SECTION 2 Elevations _ Block 01 North-East elevation

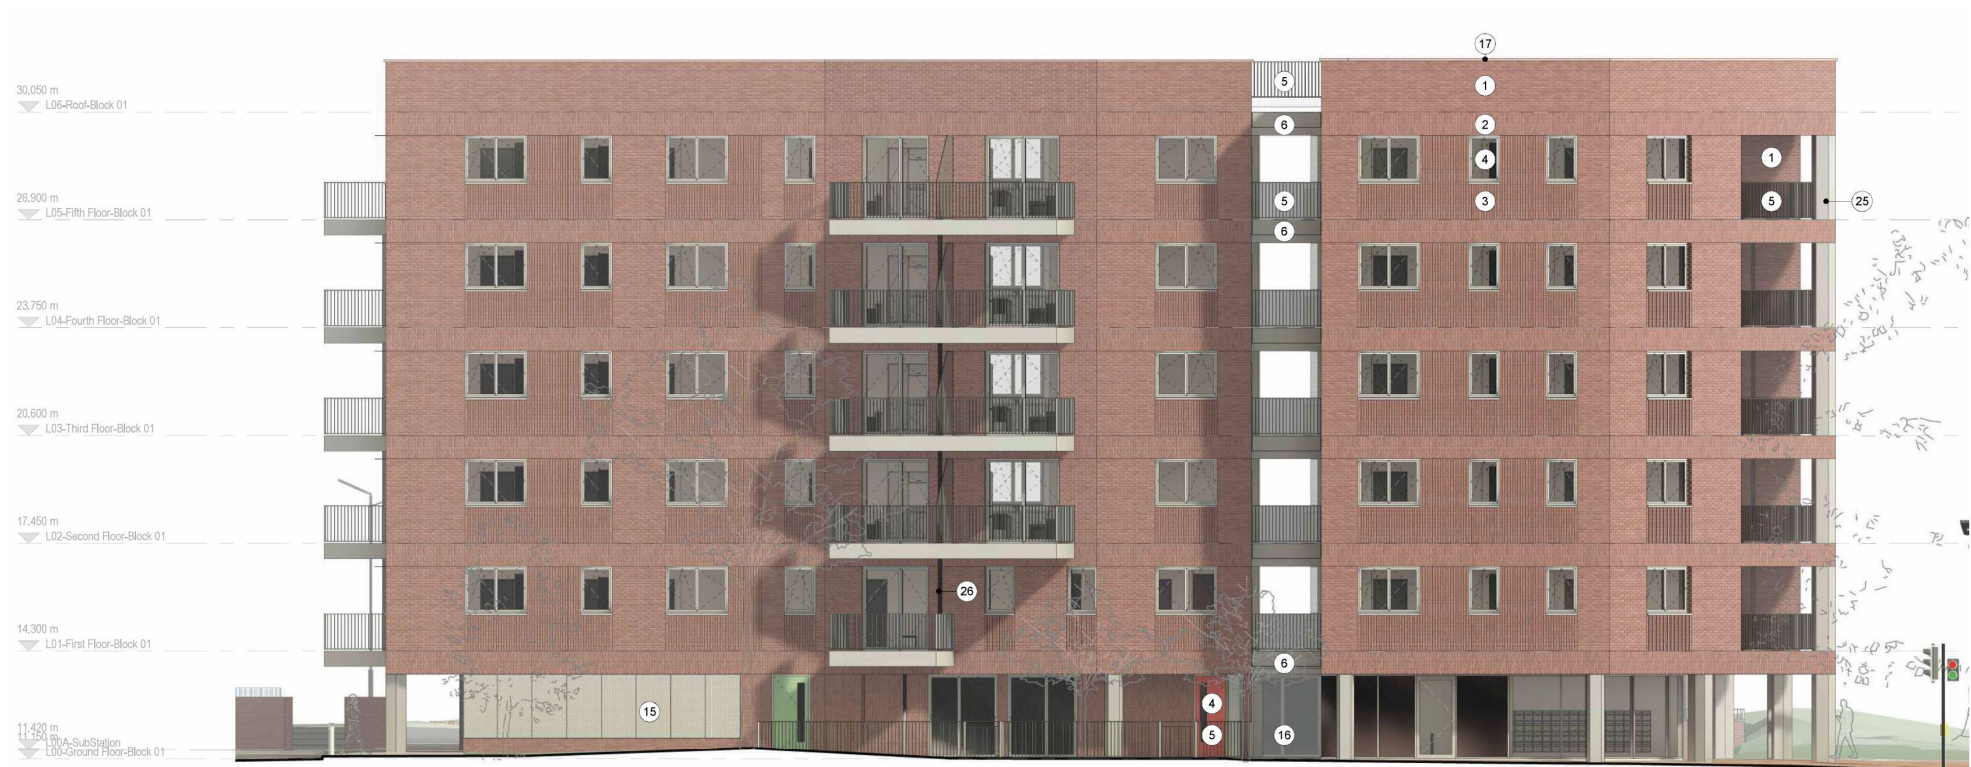
- 6. Lift lobby enclosure.
- 7. Main entrance brick pier for panelling and services installation.
- 8. Ground floor external columns clad in Ibiza white brickwork.
- 9. Aluminium metal cladding to external columns at inset balcony corner and external walkways in upper levels.
- 10/11. Brick coursing at window interfaces.
- 12. Roof bridge removed.
- 15. Canopy over entrance door added.
